Meeting:	Traffic Management Meeting
Date:	28 February 2017
Subject:	Mill Road, Cranfield – Consider Objections to Proposed Raised Table
Report of:	Paul Mason, Assistant Director Highways
Summary:	This report seeks the approval of the Executive Member for Community Services for the construction of a raised table in Mill Road, Cranfield.

<u>CENTRAL BEDFORDSHIRE COUNCIL PROPOSES TO INSTALL</u> <u>A RAISED JUNCTION TABLE IN MILL ROAD, CRANFIELD</u>

Mill Road, Cranfield centred at a point approximately 75 metres south-west of junction with Longborns.

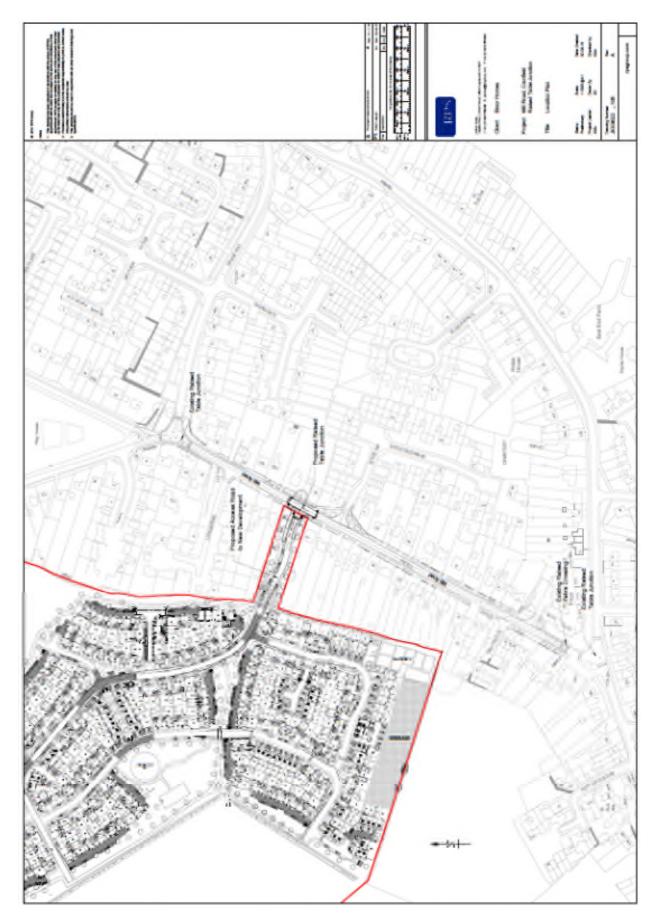
- a) The raised feature will force drivers to decelerate on approach and accelerate away, which will raise noise levels. This will be exacerbated when the new development is compete and more traffic is using Mill Road. These changes in speed will also raise exhaust gas levels.

- b) There are already three raised tables, so a further one is not required and parked cars already slow traffic down.
 - c) The homes adjacent to this stretch of road are located below road level and already suffer from flooding. Footway works made the problems worse and the raising the height of the road by installing a raise junction will increase the risk.

- d) The increase in road height will make it even harder to access/egress adjacent properties on the east side of Mill Road, particularly with a caravan.

- e) Changes to the road signage and to the road surface would be preferred to reduce vehicle speeds.

- 4. Officer response:
 - a) It is likely that some drivers will decelerate and accelerate rapidly when negotiating raised features. However, the raised feature is expected to result in an overall lowering of speeds, which is likely to reduce noise levels. The properties on Mill Road are generally set back from the carriageway, so any increase in noise and pollution levels is likely to be negligible.

- b) The existing raised features are located at either end of Mill Road with a considerable length between the raised zebra and the Crane Way junction.
 Parked cars do help to slow traffic, but during the working day the parking is relatively light. Mill Road is straight which itself encourages higher speeds.

- c) The existing highway drainage system is to be improved and additional gullies provided. There will be no additional impermeable area which will drain to private properties as a result of this scheme.

- d) The gradients involved do not appear particularly steep and it is unlikely that an increase of 75mm, which effectively takes the road level to closer to the footway level will significantly alter that. The level at the back of the footways will not increase so the gradients of the private drives to the adjacent dwellings will not increase. There will be no channel located between the raised table and the kerbline which a wheel can drop into.

- e) Raised features are deemed to be very effective at moderating traffic speeds and behaviour. The installation of signs and road surface changes are likely to have only a marginal effect, so are not an effective substitute for the proposed raised table.
